**FINAL FINDINGS AND DECISION BY THE DESIGN  
COMMISSION RENDERED ON April 2, 2015**

**CASE FILE NUMBER: LU 14-251633 DZM  
PC # 14-231712**

**The International School New Classroom Building**

SOUTH (SW CARUTHERS ST) ELEVATION

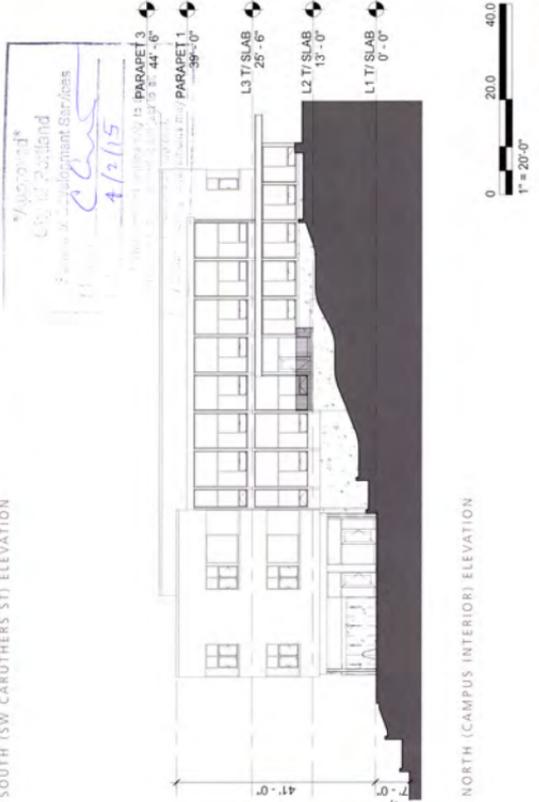
- B.** Replace the portion of concrete wall on the ground level south façade facing the lower Entry Plaza and SW Caruthers Street with aluminum-clad wood windows to match the Common Areas.

**GLASS HERE  
NO CONCRETE**
